PLAN COMMISSION

- a. Ryan Janssen, representing Avery & Birch, for a recommendation for Preliminary Approval of a new building consisting of a three-story salon suite facility, located at 21055 Crossroads Circle.

Strand Associates, Inc.® (Strand) has finished its third review of the plan package for the Avery and Birch Development that was received from the Town on December 28, 2023, for conformance with the Town specifications and general engineering practices. New drawings and a letter describing the revisions were returned to Strand on January 17, 2024, from Jenswold Development (Developer) after Strand's concerns from its January 8, 2024, letter were addressed (shown in the following). A third response letter with submittal was received by Strand from the Town and Developer on February 7, 2024, along with an updated Stormwater Management Plan on February 13, 2024. The most recent Developer responses are included in *italics* and Strand's current comments are in **bold**. Before construction may begin, the contractor shall submit all required permits for the development to the state, Wisconsin Department of Natural Resources, Town, and any other relevant agencies.

CONSTRUCTIO

WB-50 TURNING MOVEMENT EXHIBIT

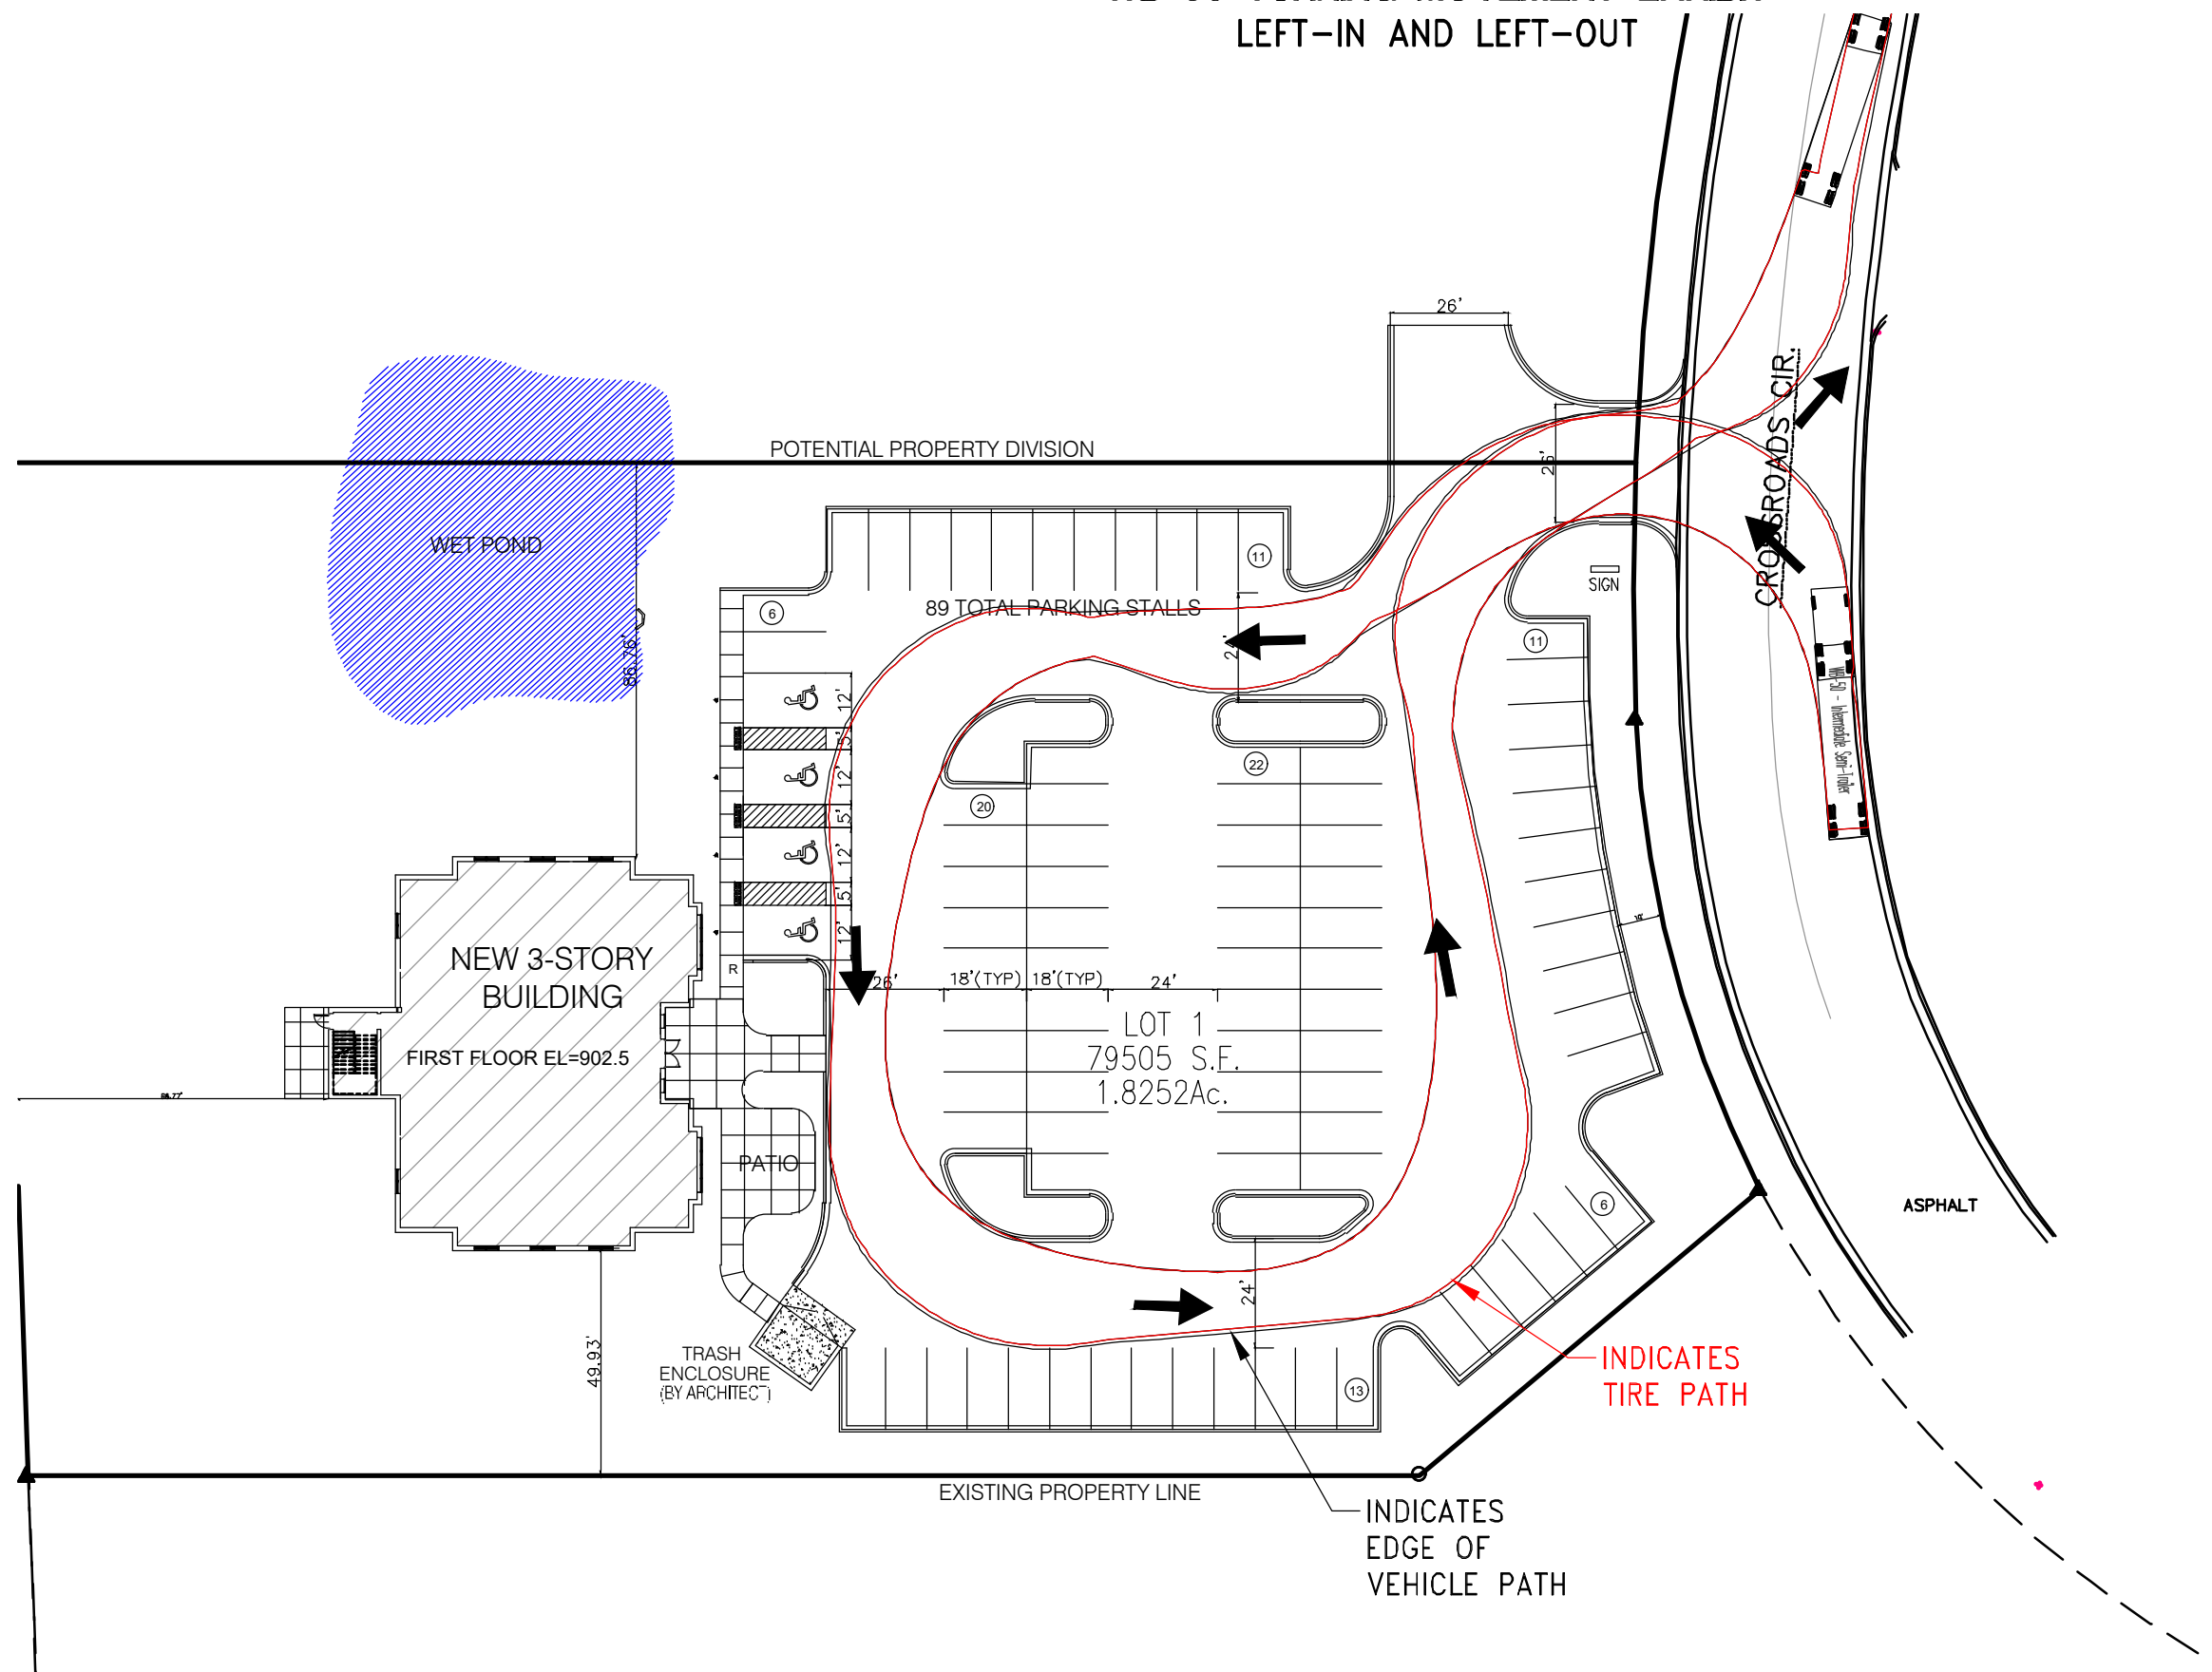
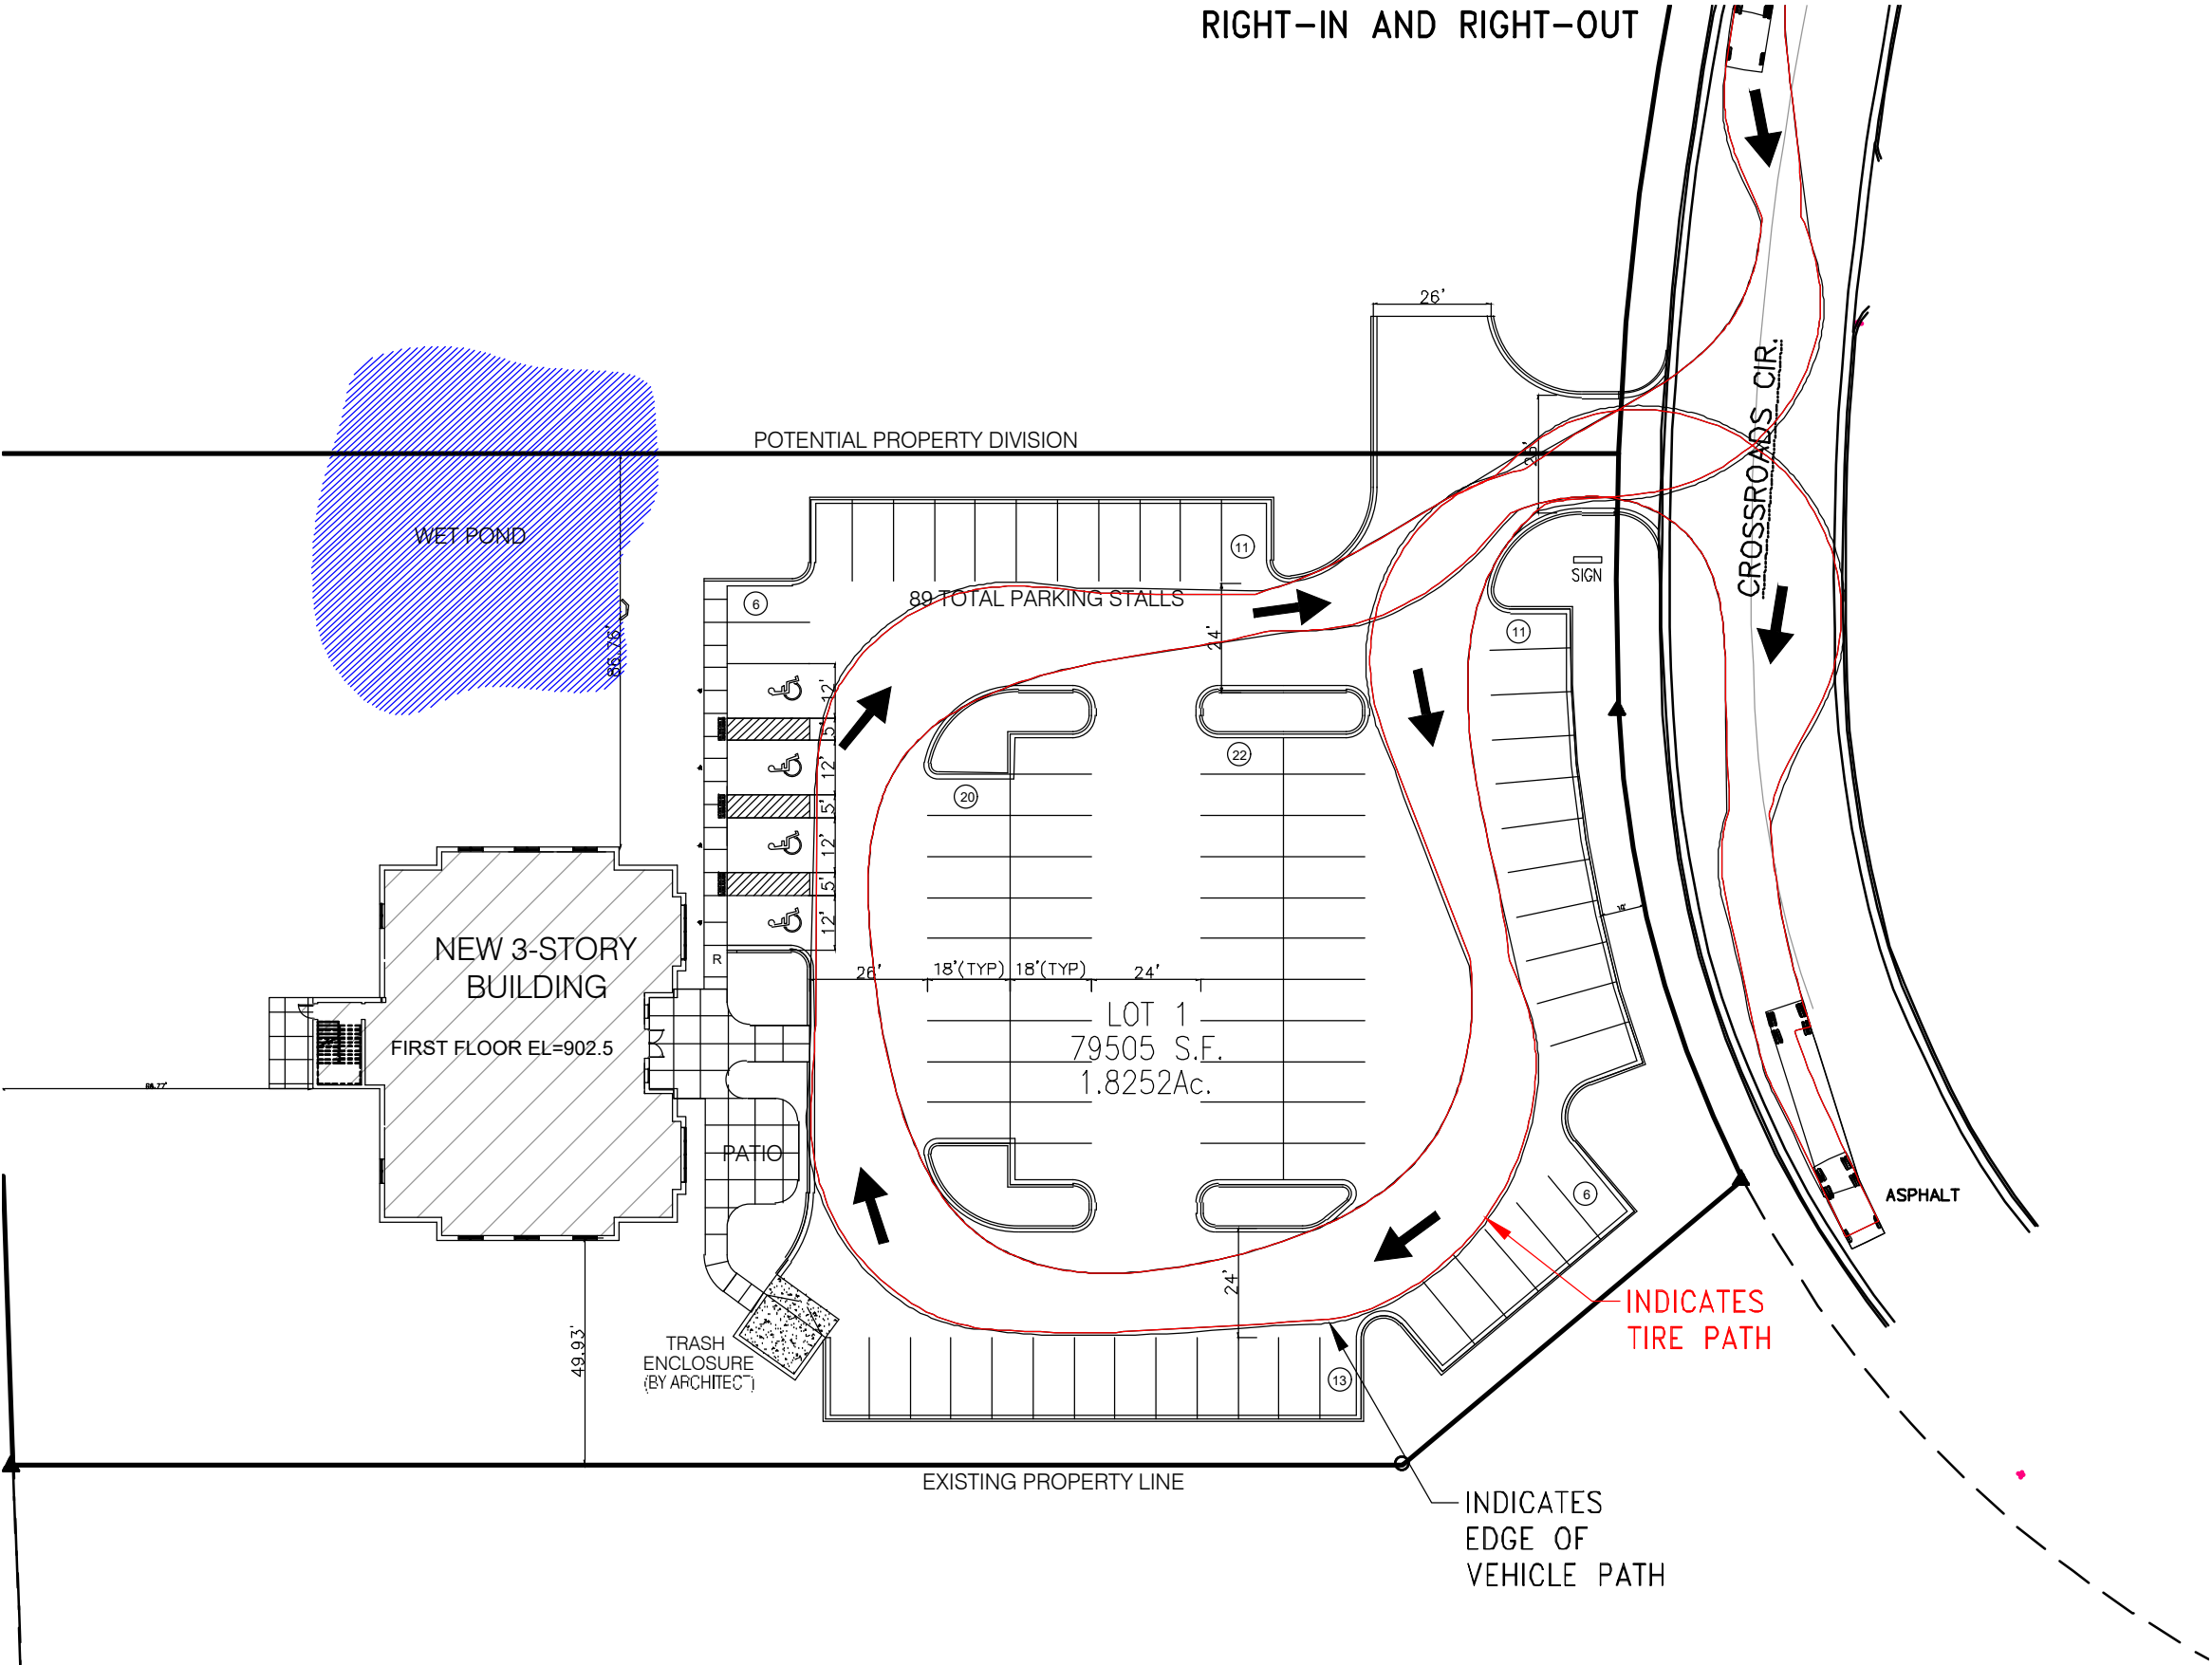
Strand's January 25, 2024, Comment—It appears the truck used in the turning template is 30 feet long by 8 feet wide. The Town of Brookfield Fire Department requests that a WB 50 design vehicle be used for the turning template. Please update the turning template exhibit using a vehicle of this size and also show the truck is able to enter and exit the proposed driveway from Crossroads Circle.

Strand's Current Comment—The turning templates were reviewed and there is no further comment.

Developer's January 31, 2024, Response—Parking lot adjusted and an auto turn analysis has been prepared to address this comment using a WB-50 template.
